## 1 Products affected

## 2 Type of change

Product Change Notification					PCN DFKH-14 round pins		
owner	creation date	release date	released by	change order no	rev	page	D10-045-928
segatro	26.05.2020	03.02.2021	blumhe	2019984	A	1 of 1

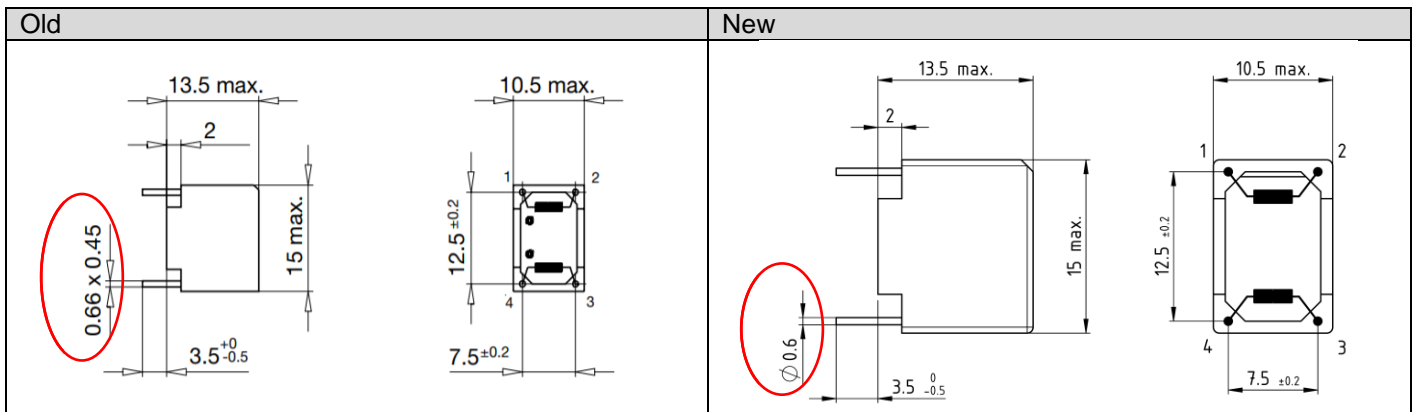
- Terminal pins changed

- Rectangular pins substituted with round pins

Form	No	-
Fit	Yes	Pin diameter and shape
Function	No	-
Manufacturing	No	-
Label	No	-
Packaging	No	-
